MINERALS PROGRAM INSPECTION REPORT

MINE NAME: Simla Highway Pit	MINE/PROSPECTING ID#: M-1995-095	MINERAL: Gravel	COUNTY: El Paso
INSPECTION TYPE: Monitoring	INSPECTOR(S): Timothy Cazier, P.E.	INSP. DATE: May 4, 2022	INSP. TIME: 13:50
OPERATOR: Hill Top Gravel LLC	OPERATOR REPRESENTATIVE: Blake Tope	TYPE OF OPERATION: 110c - Construction Limited Impact	
REASON FOR INSPECTION: Normal I&E Program	BOND CALCULATION TYPE: Partial Bond	BOND AMOUNT: \$14,462.00	
DATE OF COMPLAINT: NA	POST INSP. CONTACTS: None	JOINT INSP. AGENCY: None	
WEATHER: Cloudy	INSPECTOR'S SIGNATURE: 	SIGNATURE DATE: September 2, 2022

Photo 2. Small access road shown on Figure 1 as a dashed red line.

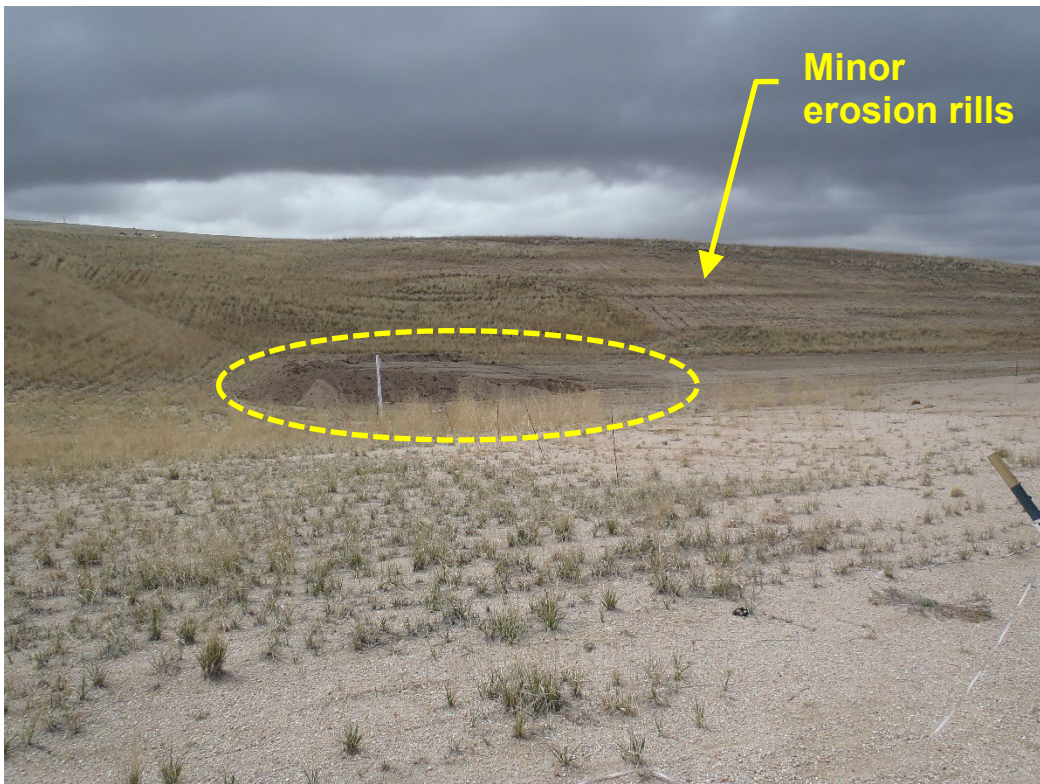
Gen. Compliance with Mine Plan: The operation appeared to be in compliance with the approved mine plan at the time of the inspection. The maximum allowed disturbed area for the purpose of bonding is 2.65 acres (which includes the one-acre sediment pond as long as no grading is involved). An additional bond is held for four acres that have been revegetated, but are still in the permit [*assuming a 25% failure rate – or for one equivalent acre of seeding*]]. There is a short segment between the sediment pond and the new active mining area that is not technically covered under the TR-2 approval (see **Photo 2** dashed redline on **Figure 1**). As neither the new active mine area or the topsoil stockpile have reached their approved maximum area (shown on **Figure 1**), there is sufficient bond. [However, future permit revisions should be sure to incorporate haul/access roads.](#)
